From: Oriana Garcia [REDACTED]
Sent: Monday, 13 February 2023 8:36 PM
To: Planning Panels - Northern Beaches
Cc: Adam Rytenskild
Subject: DA 2022/0469 NBPP Submission Adam Rytenskild
Attachments: Submission Letter re 1102 Barrenjoey Road.pdf

**SUBMISSION TO DA 2022/0469
NO. 1102 BARRENJOEY ROAD, PALM BEACH
CONSTRUCTION OF SHOP TOP HOUSING**

1.1 Issues relating to Building Height non-compliance

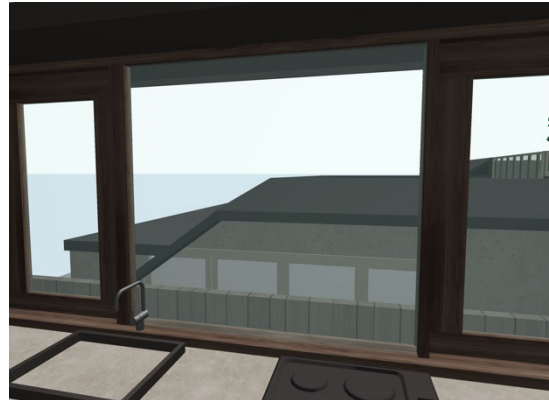
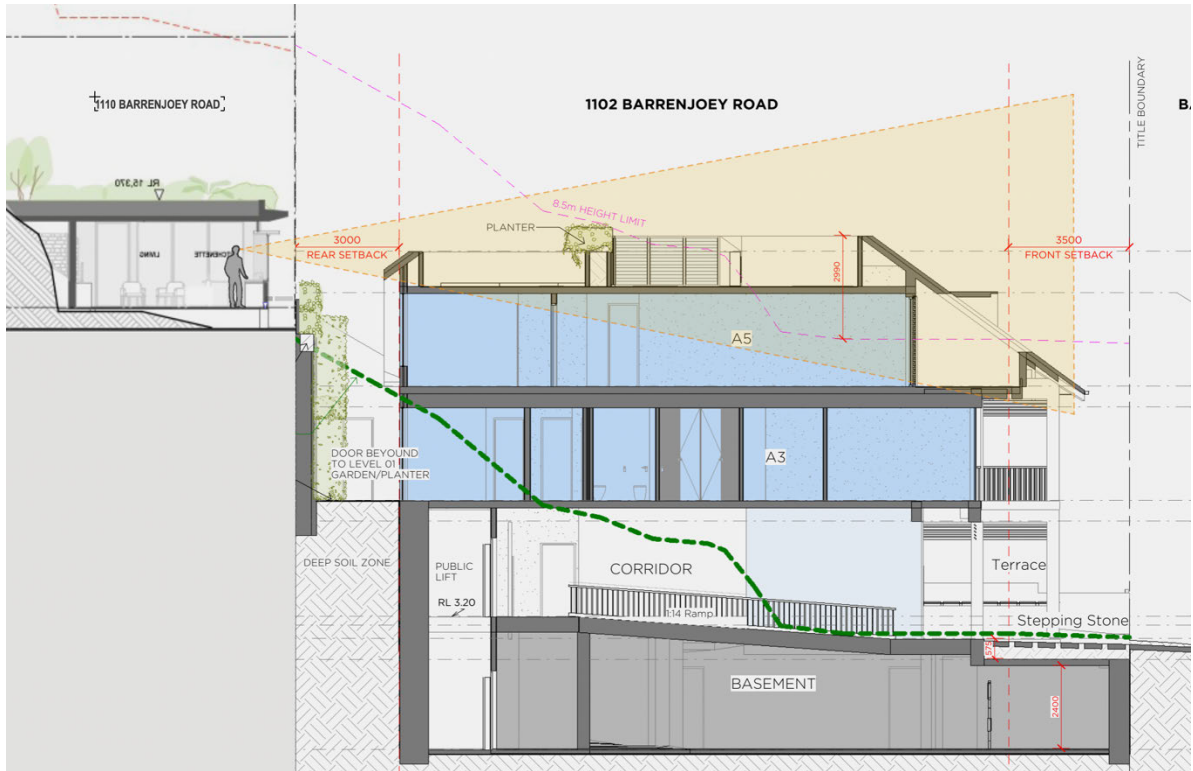
The permissible height of the building application the site is 8.5m as referenced in LEP clause 4.3, which the proposal exceeds by approximately 3 metres. This is a substantial variation in the order of 35%. This means that most of the second storey and roof level is almost entirely above the LEP height limit. This additional height is a breach of a development standard. The proposal is also materially higher than the previously approved development application and hence this cannot be used as a reason to provide such a gross exception to the LEP.

The additional height is not consistent with the objectives for Height of Buildings which include 'to ensure that any building, by virtue of its height and scale, is consistent with the desired character of the locality,' 'to ensure that buildings are compatible with the height and scale of surrounding and nearby development,' and 'to minimise the adverse visual impact of the development of the natural environment, heritage conservation areas and heritage items'. We would contend the proposal is not compatible with the desired future character of the area and surrounding buildings, as the proposal has not minimised the adverse effects of bulk and scale. Instead, it will be overbearing bulk adjacent to Barrenjoey House, a heritage item. When compared to Barrenjoey House, the proposed roof is almost double in size and height making it its most dominant visual feature.

Due to the additional height, the proposal is also not consistent with the objective 'to allow for reasonable sharing of views.' Specifically, the proposed roof impinges on private views from our approved Bungalow towards Pittwater and Ku-ring-gai Chase National Park. Please refer to superimposed section below.
